KEYSTONE ELECTRONICS CORP.				
www.keyelco.com • NEW HYDE PARK NY 11040 • Tel (516)328-7500				
PART NAME				
NYLON CABLE CLAMP				
MATERIAL				
.050 [1.27] TH'K NYLON 6/6				
FINISH	DRN BY BOONE DATE 11.02.06			
NONE	APP'D SCALE			
	RH 1.2X			
TOLERANCES INCH [MM] CODE	DWG NO.			
DECIMAL ± .015 [± 0.38] ANGULAR ± 1° UNLESS OTHERWISE SPECIFIED	7636

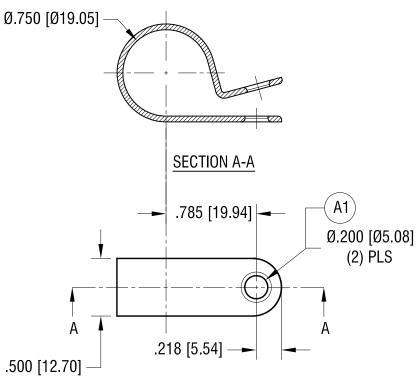
11.01.21	A1) WAS 203 [5.16] CHANGED AS PER ECN 21-122	A
DATE	DESCRIPTION	REV.
